Superfund Record of Decision:

Rocky Hill, NJ

REPORT DOCUMENTATION PAGE		1. REPORT NO. EPA/ROD/R02-88/061	2.	3. Recipient's Accession No.	
4. Title and Subtitle SUPERFUND RECORD OF DECISION Rocky Hill, NJ First Remedial Action - Final				5. Report Date 06/30/88

III. SUMMARY OF MAJOR QUESTIONS AND COMMENTS RECEIVED DURING THE PUBLIC COMMENT PERIOD AND NJDEP'S RESPONSES

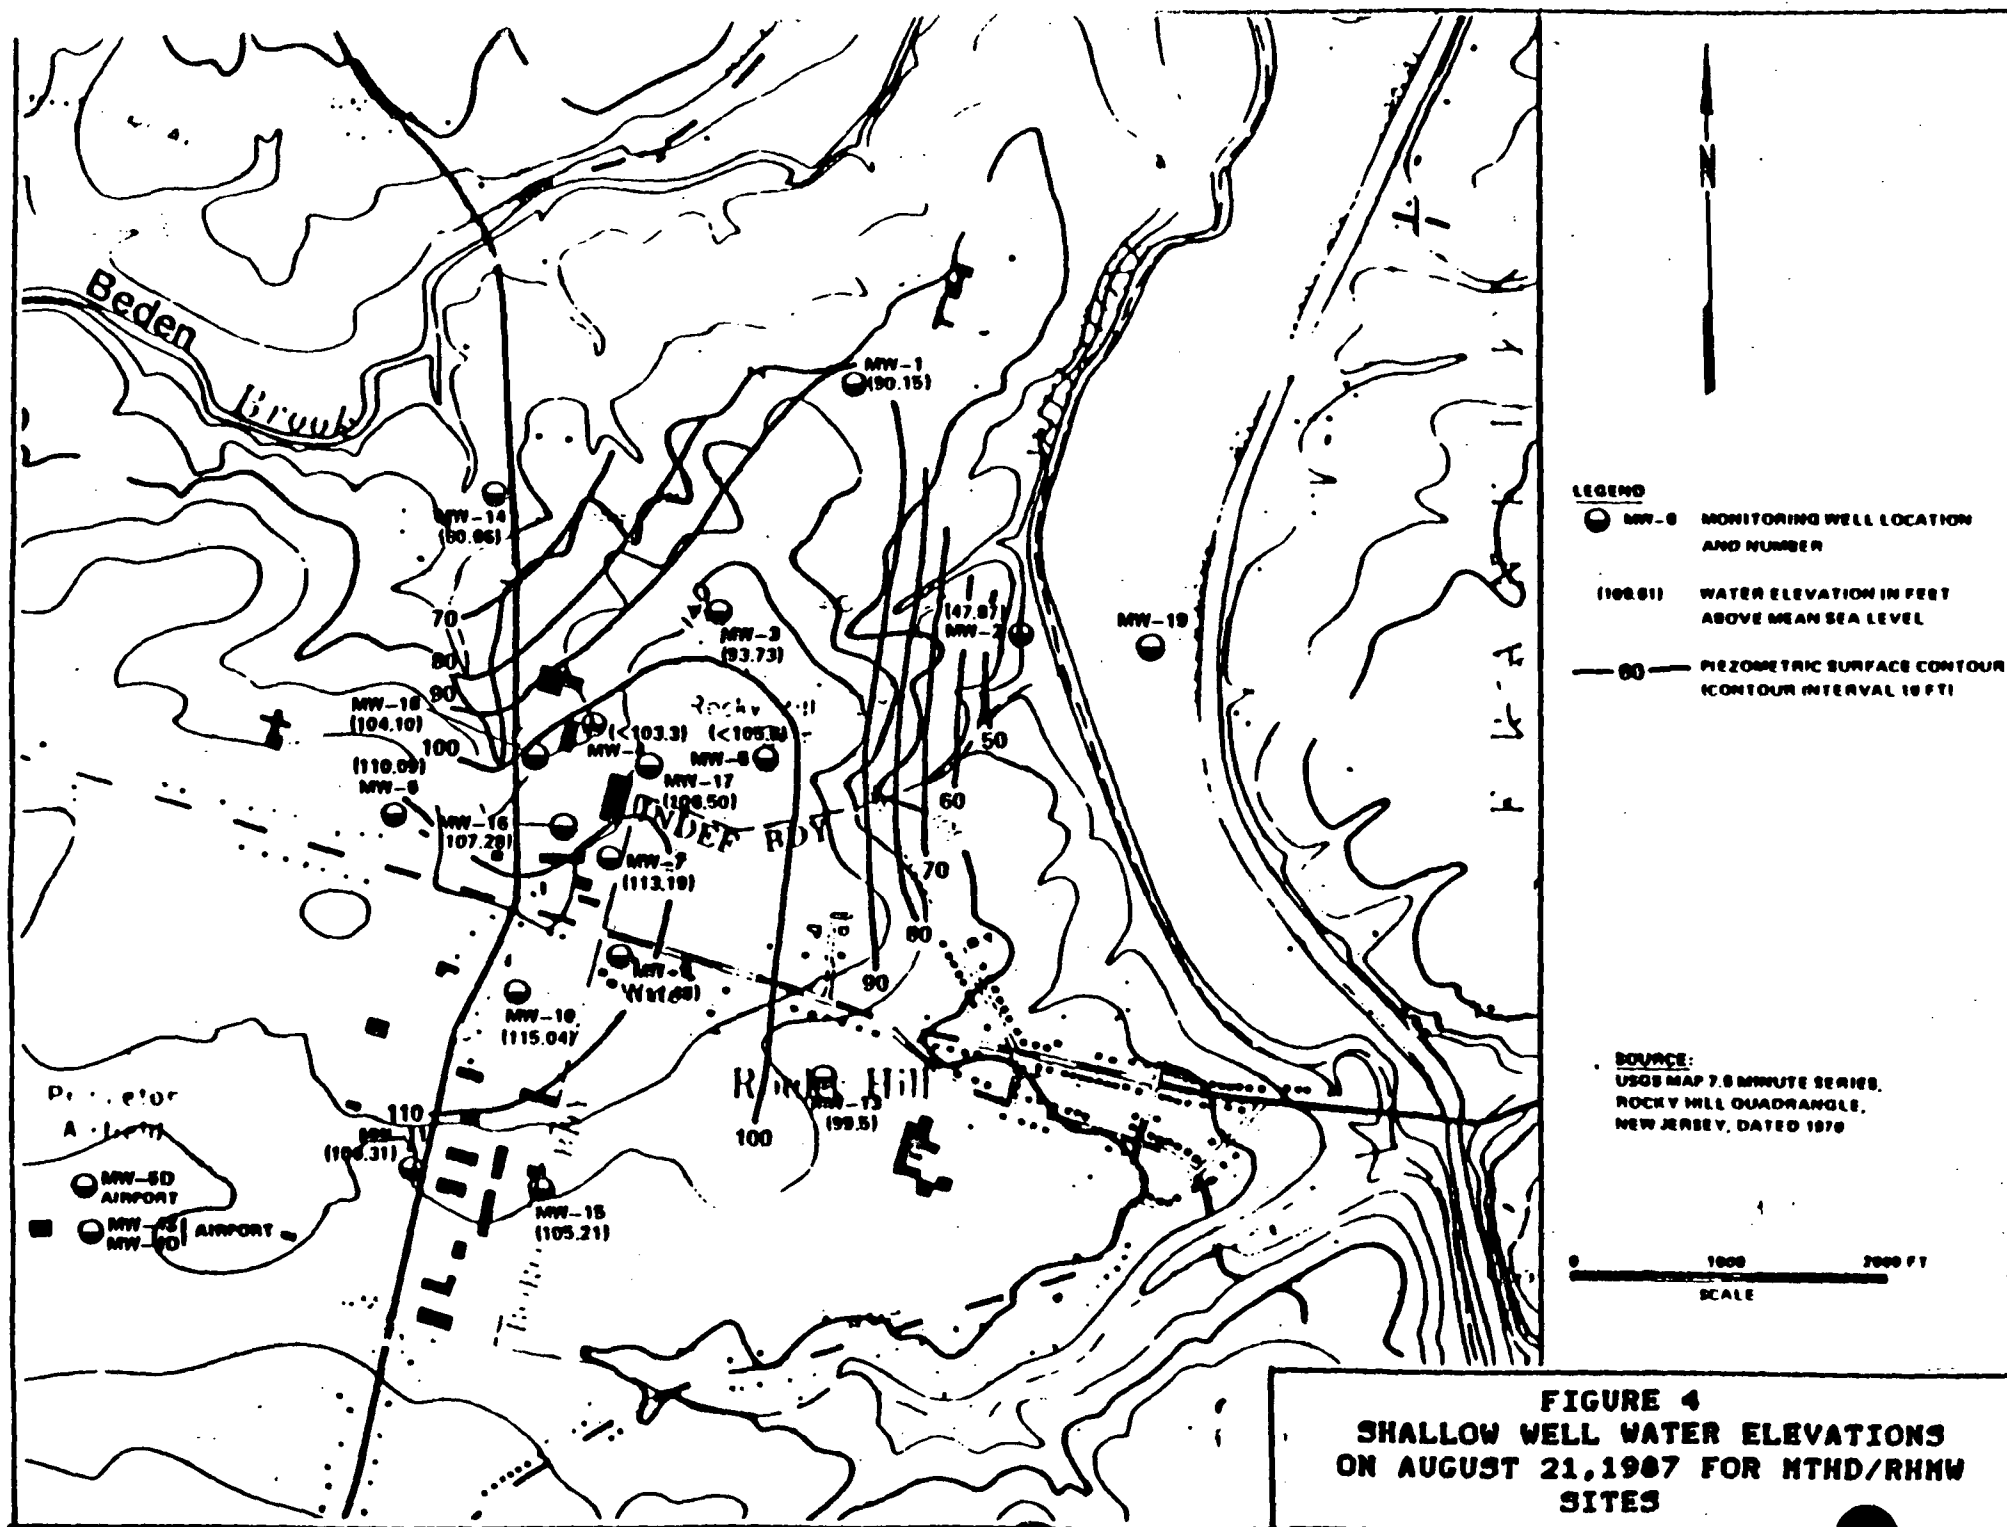
5. What is the location of the tank farm referenced on the RI (at 3-10) and the spray waste irrigation area? Is the disturbed area identified by G & M (Figure 4) the tank farm and/or the irrigation area? Finally, why were soil samples taken and monitoring wells installed outside the disturbed area identified by G & M and no samples taken or analyses conducted in the tank farm or spray waste irrigation areas?

Response: The waste discharge area behind the property once operated by Princeton Chemical Research (PCR) has been identified as the patch of white sand clearly evident in aerial photos. This area is the location of SB-2. The tank farm at the PCR facility is the rectangular area of graded land immediately behind the building. Soil boring SB-3 is in this location.
